**United Kingdom Holocaust Memorial  
and Learning Centre**

Design and Access Statement Addendum  
April 2019

The revised proposal retains the original Masterplan and incorporates the following amendments:

- Revised design for the Entrance Pavilion;
- Adjustments to the design of the memorial courtyard and associated landscaping;
- Rationalization of the Learning Centre footprint
- Extension of the Learning Centre Mezzanine level;
- Repositioning of the skylight within the landscape

**Site Constraints**

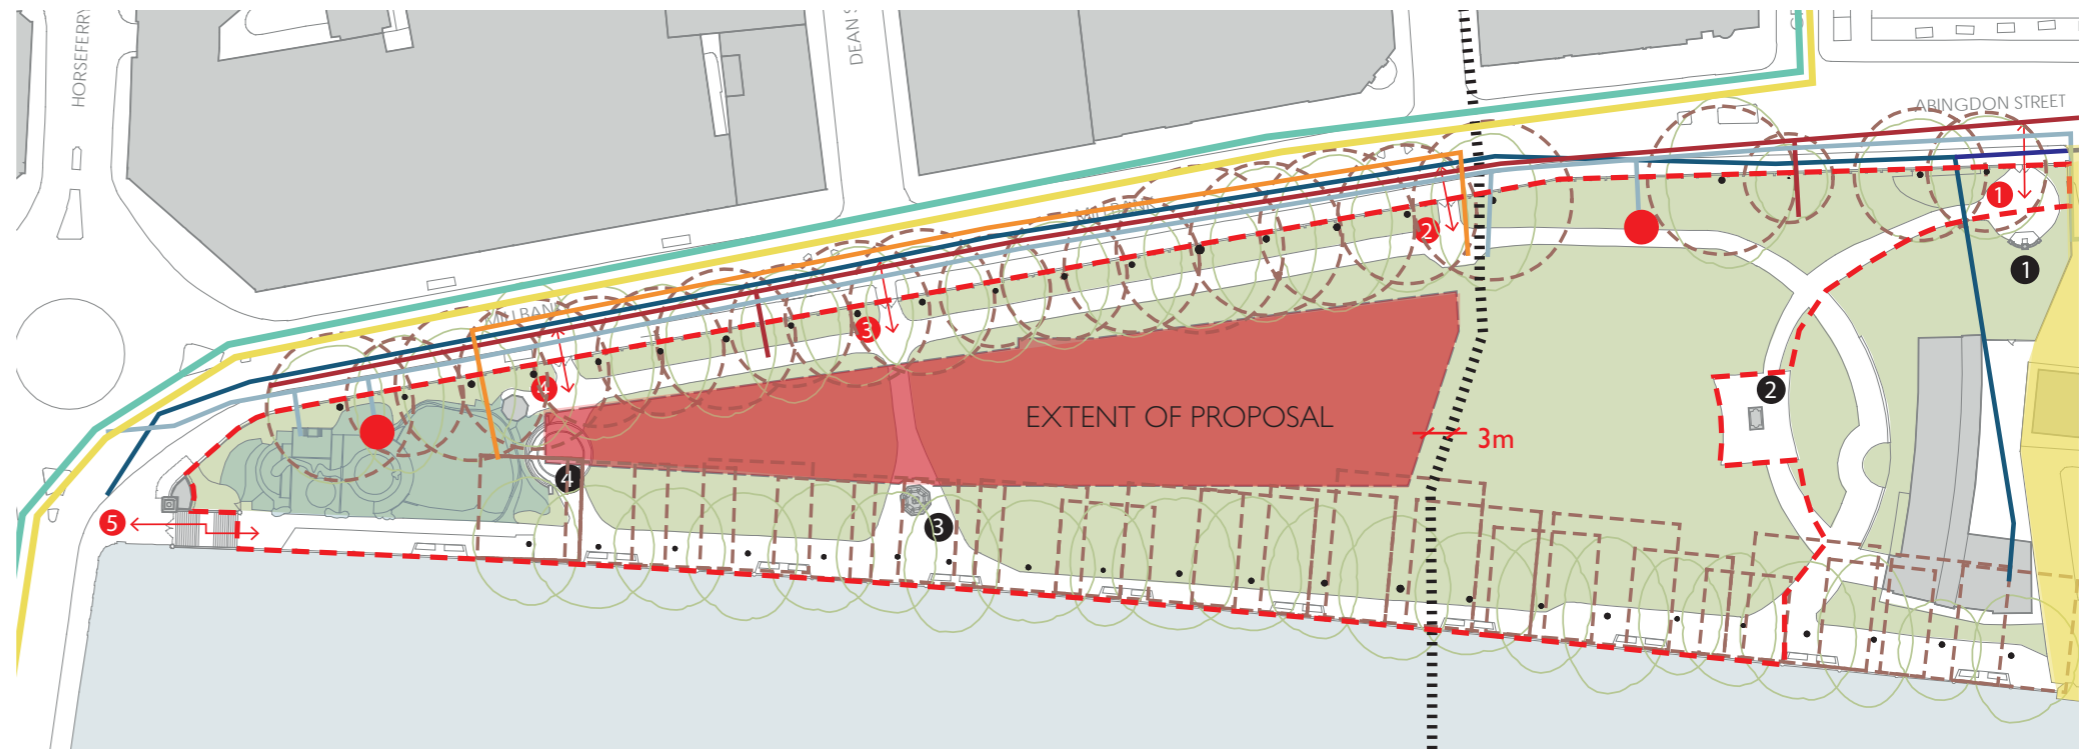
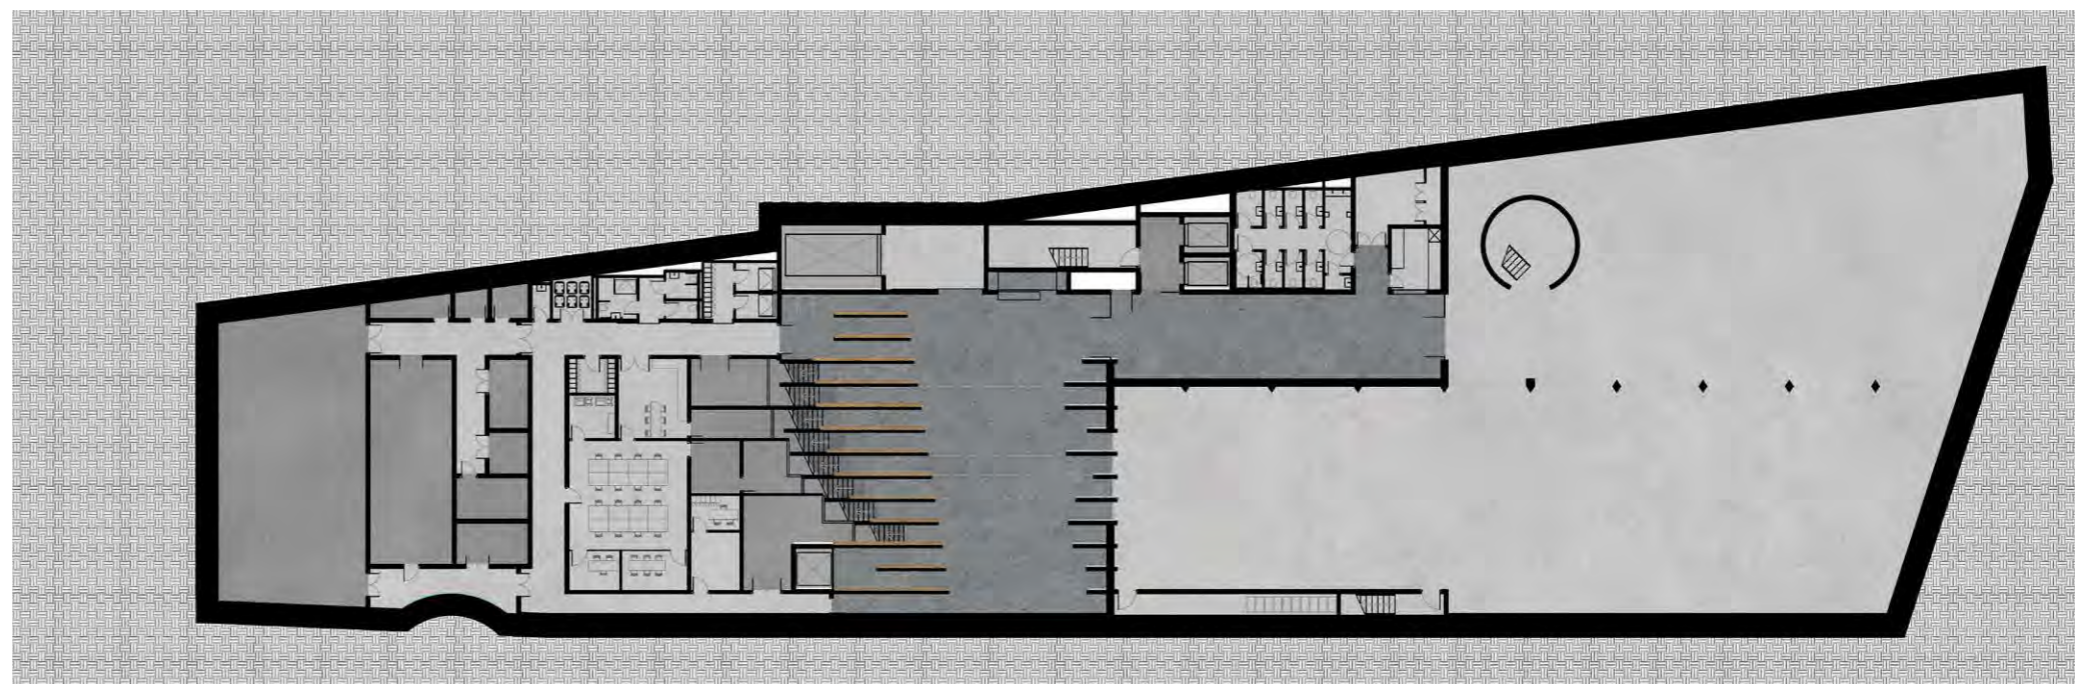
Compared to the December 2018 Application, the new building footprint pulls the building away from the trees at the northwestern end and from the existing Thames Storm Overflow Sewer, by reducing the size of the basement footprint. This also reduces construction time/excavation and improves logistics on site.

### April 2019 Amendment

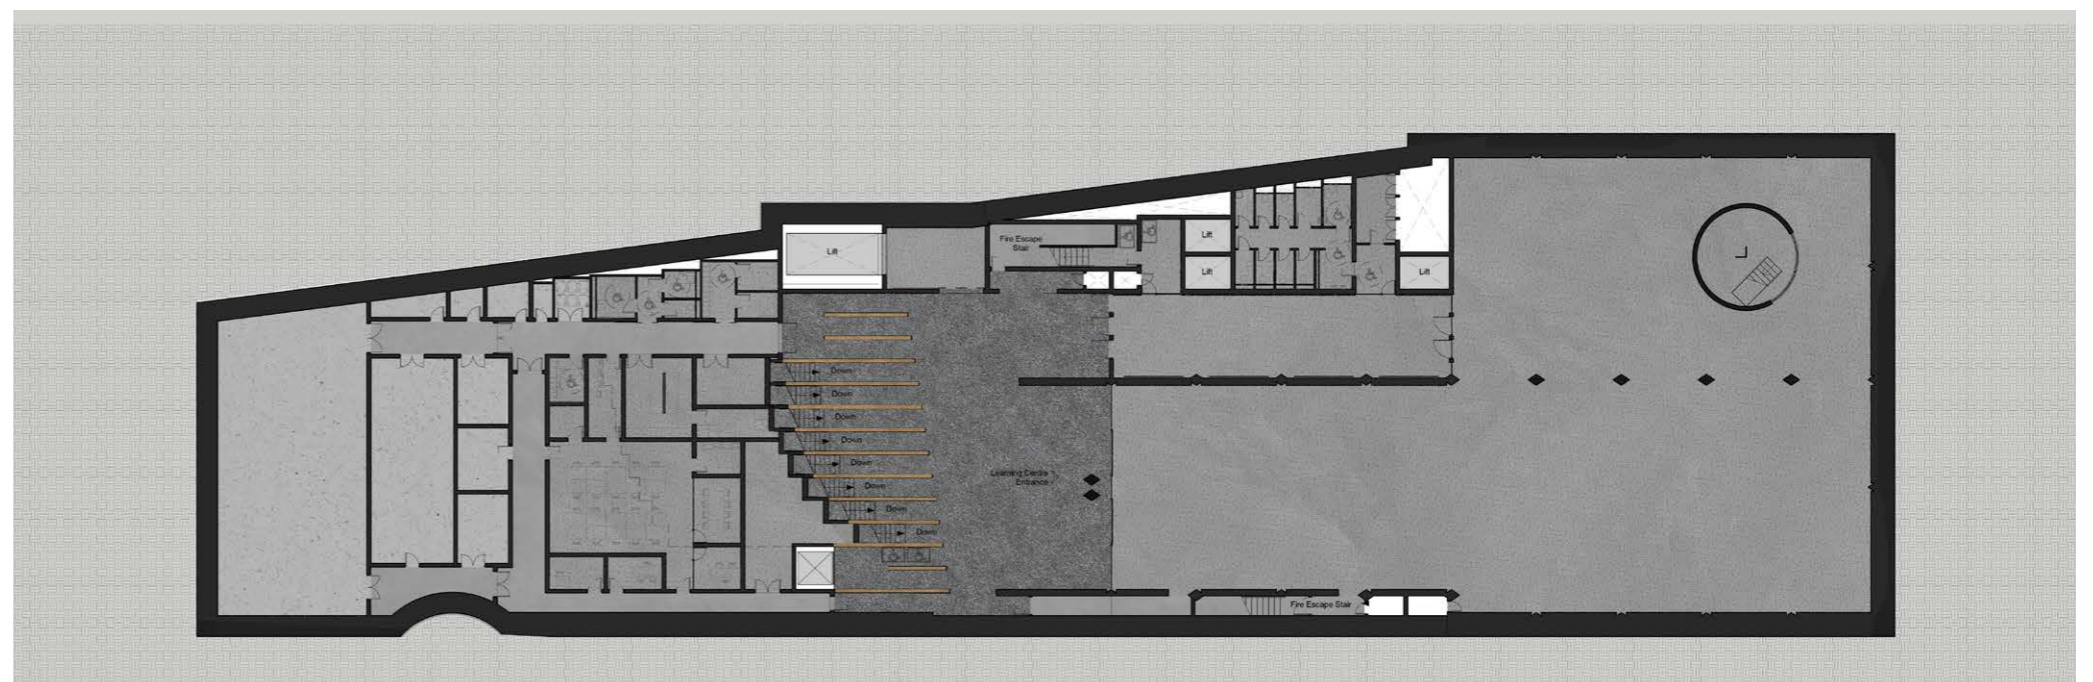
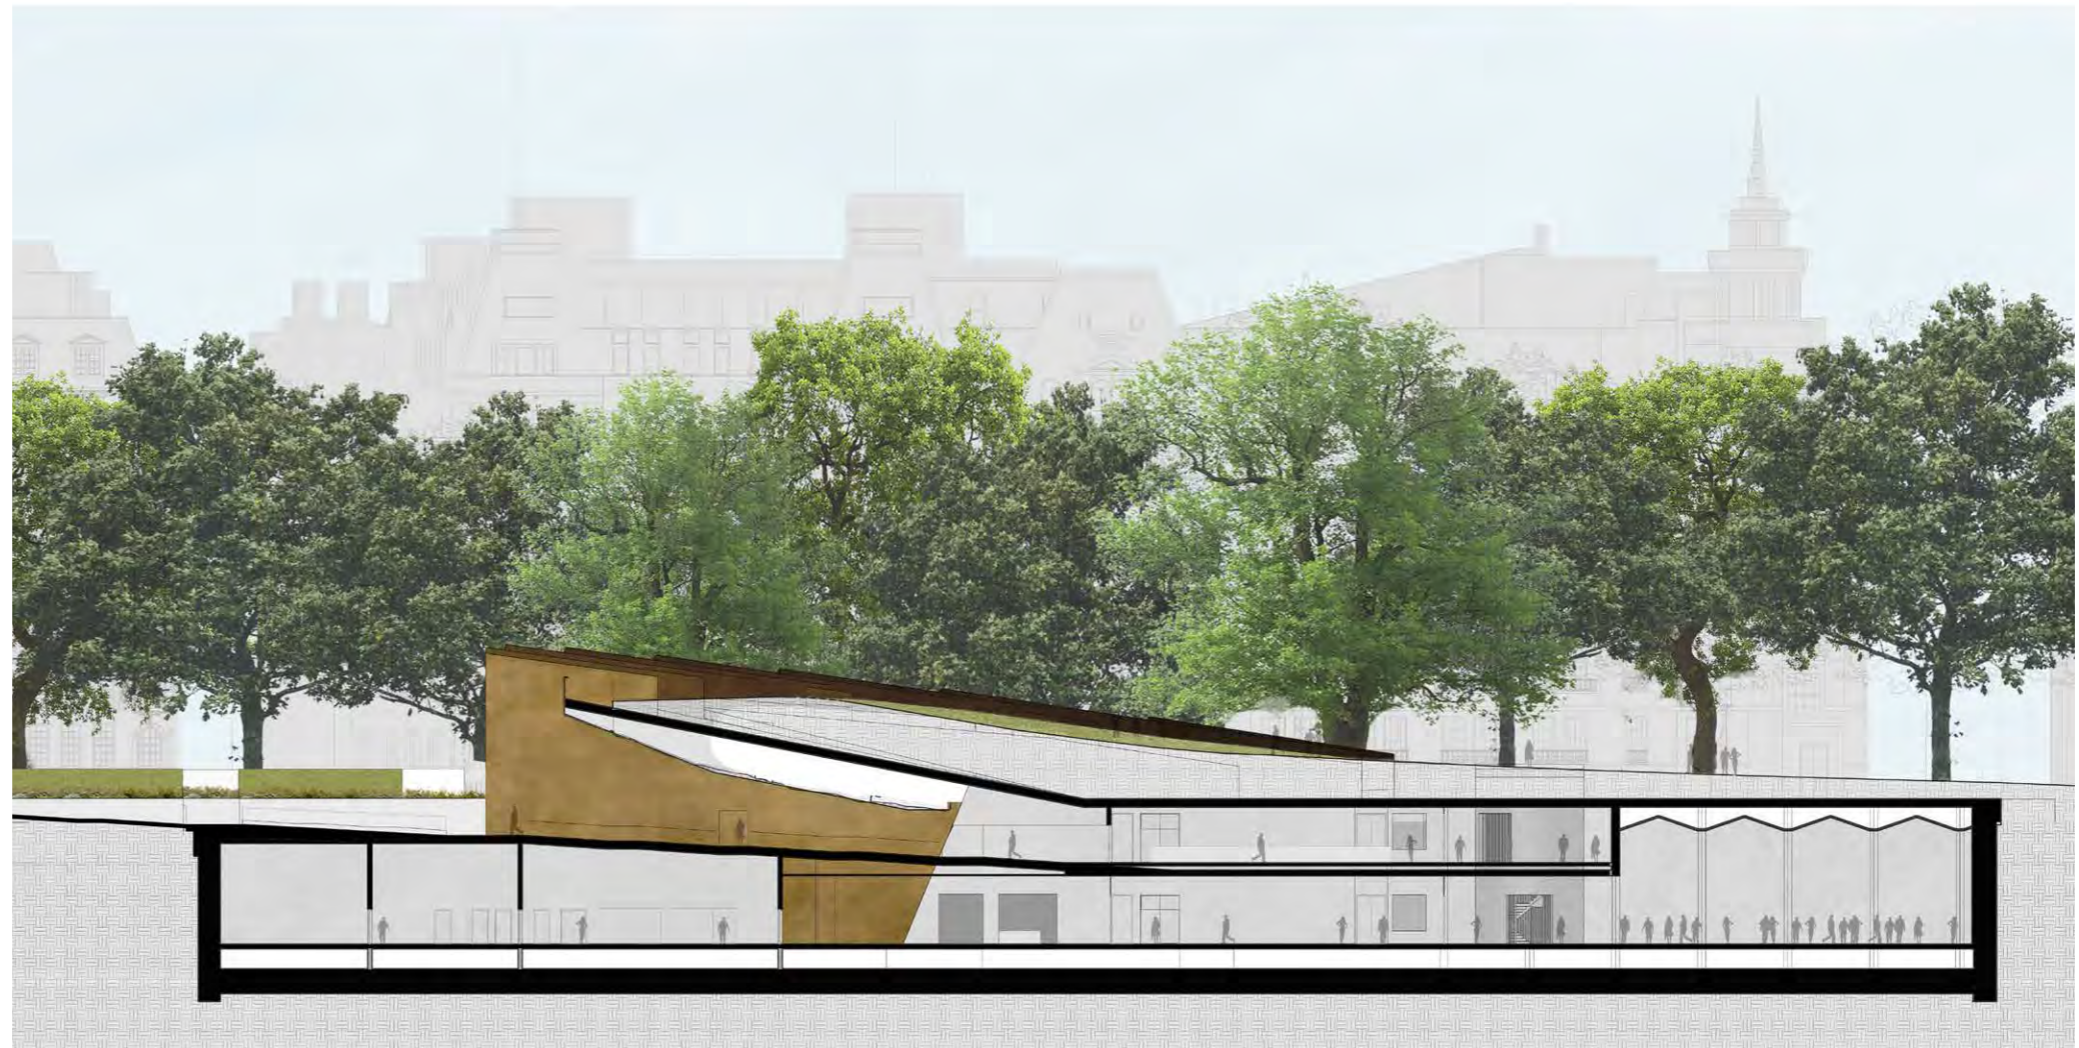
The new basement plan is reduced by 213sqm and the skylight has been relocated further north.

April 2019 Amendment

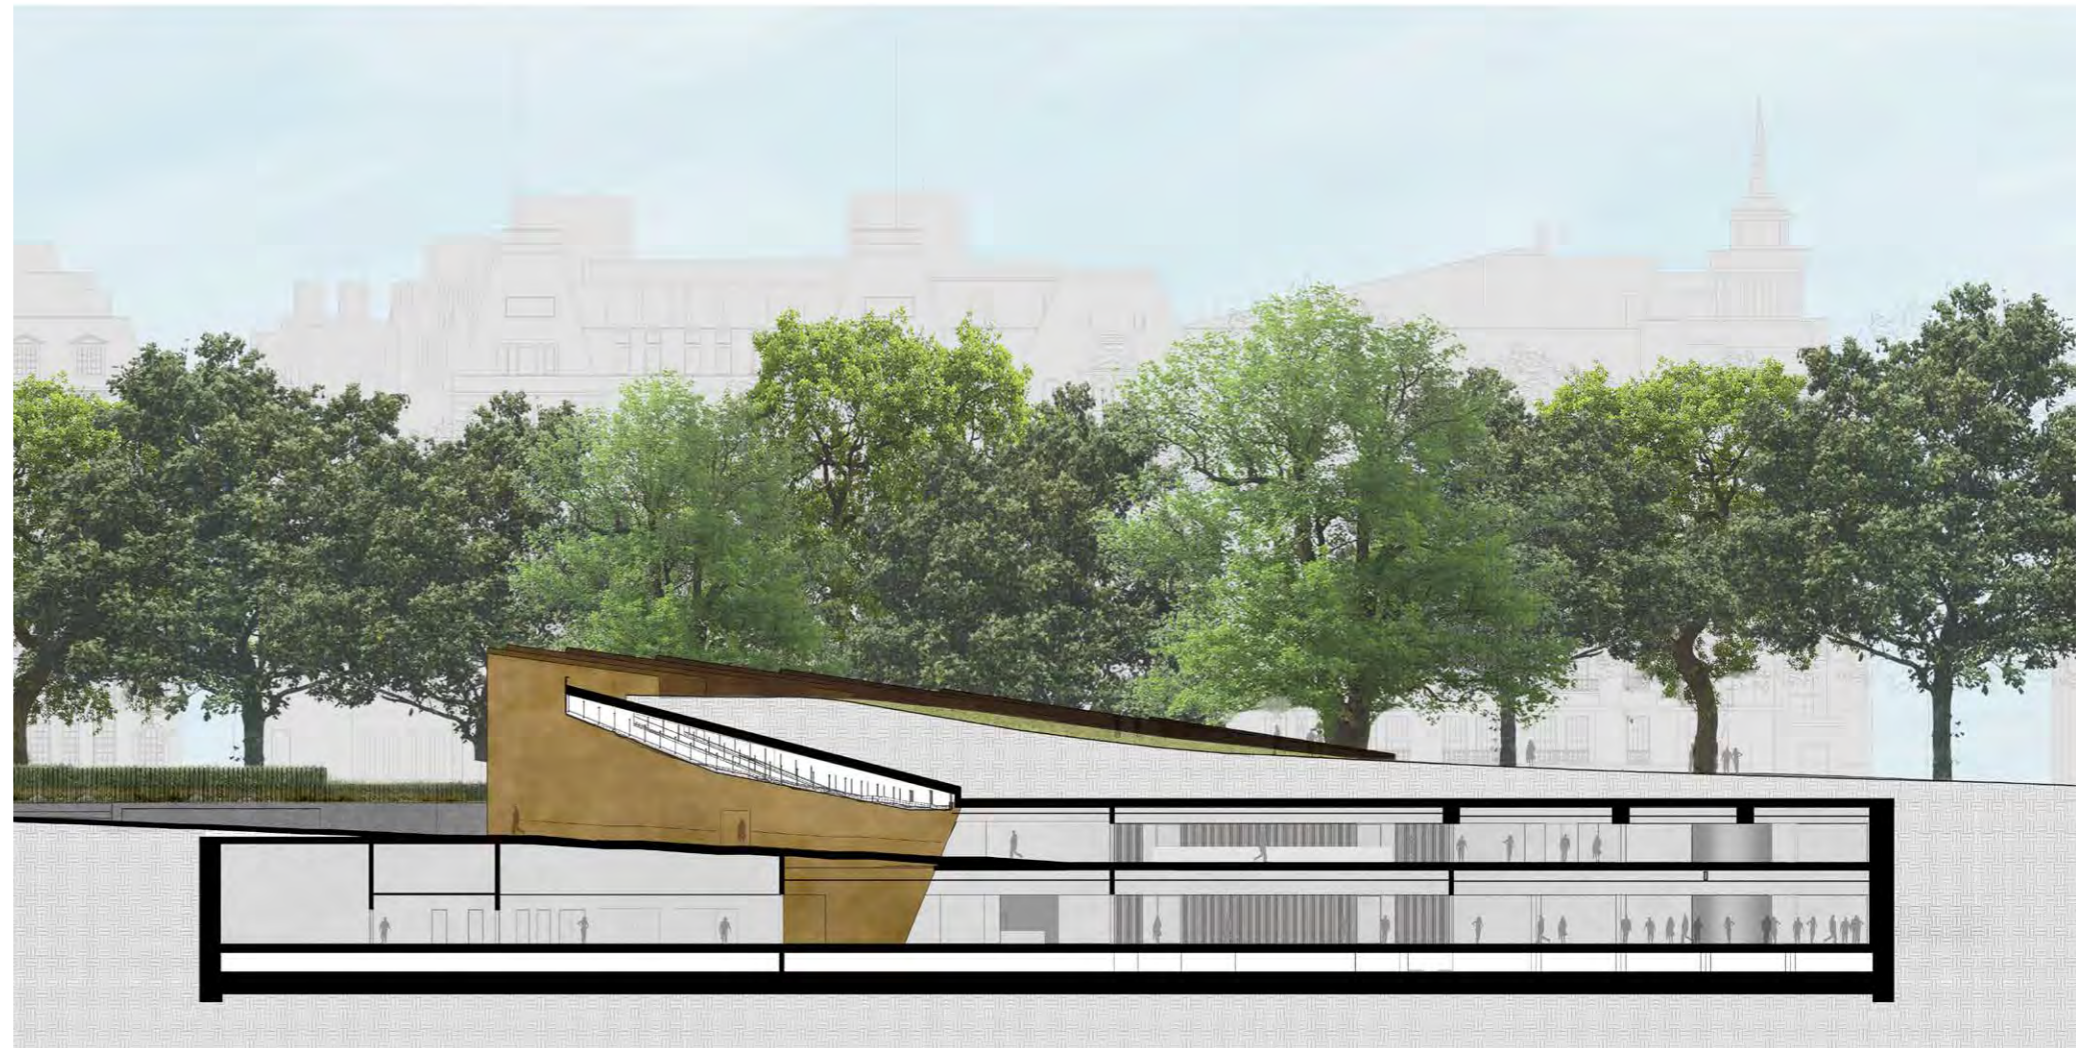
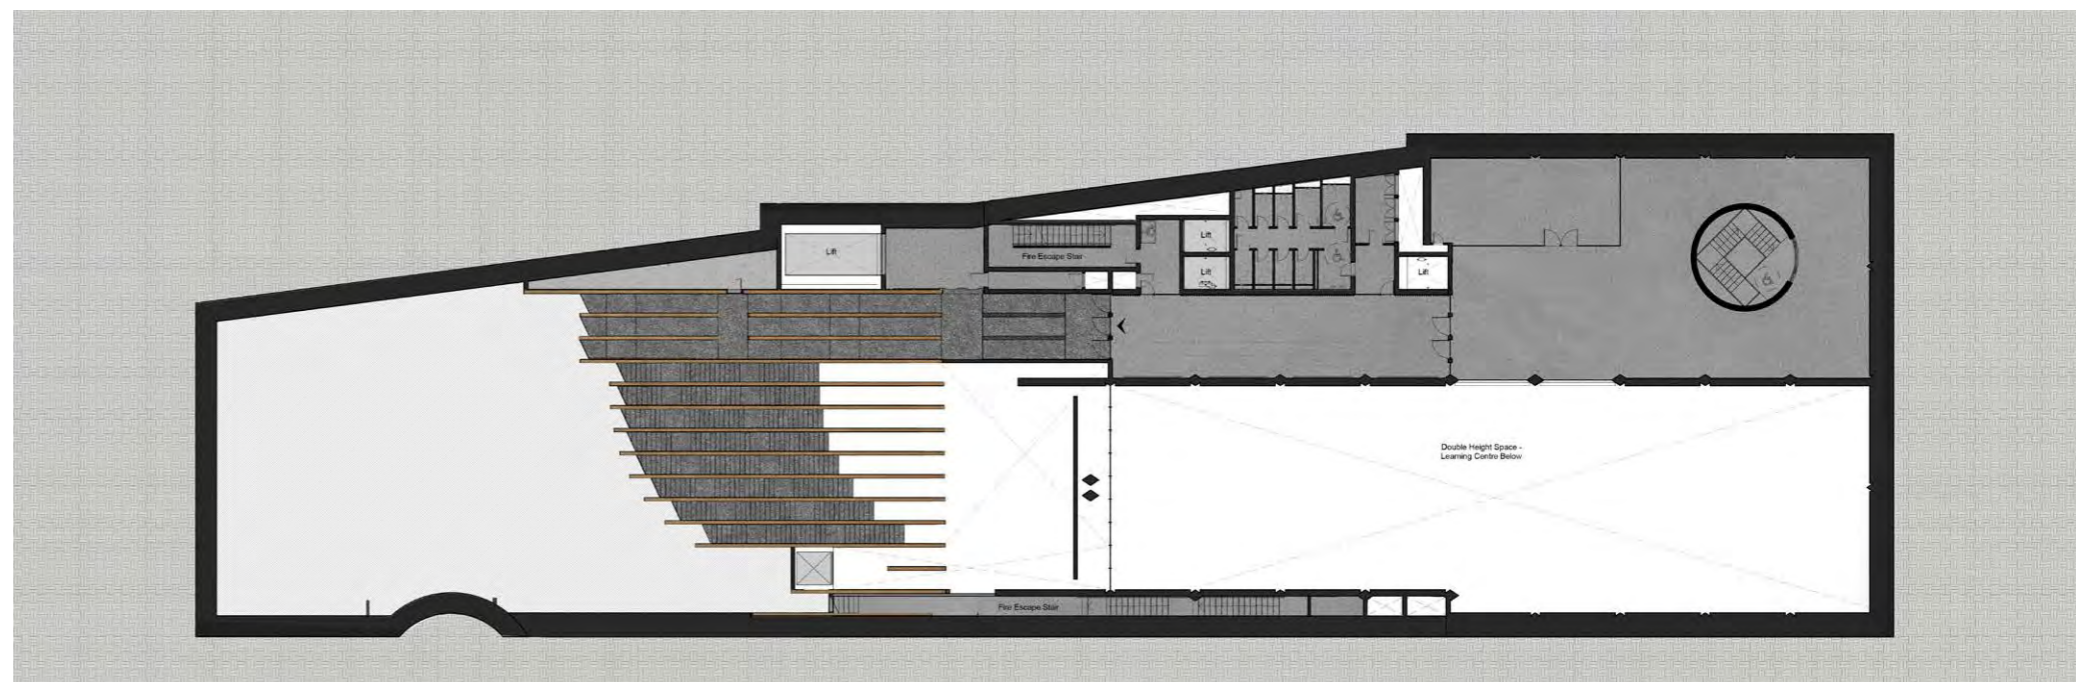
The Mezzanine level was extended by 213sqm in order to maintain the same quantum of floor space required for the exhibition area.

View 9: TC4

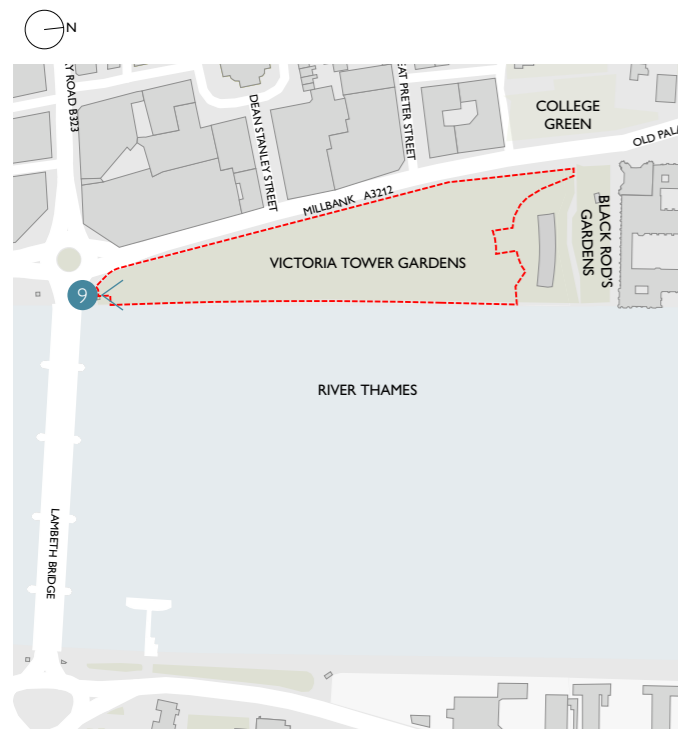
- 2.2 View 9 (Fig. 1) – looks down Embankment steps past proposed café, Playground and UKHMLC Entrance Pavilion beyond. The main change to the view is that the reconfigured and lowered Entrance Pavilion roof will enable more of the bronze Memorial Fins to be more visible beyond. The proposed Museum entrance will therefore have greater visibility in the view than the Entrance Pavilion, which will become less of a focus in the view. Similarly, in the additional verified view from the playground itself (not provided in my original Statement), View 23 (Fig. 2), the proposed Memorial Fins will have greater visibility as will the lower parts of the Palace of Westminster, its backdrop: the silhouette of the Memorial Fins will create a visually powerful relationship with the distant pinnacles of the Palace.
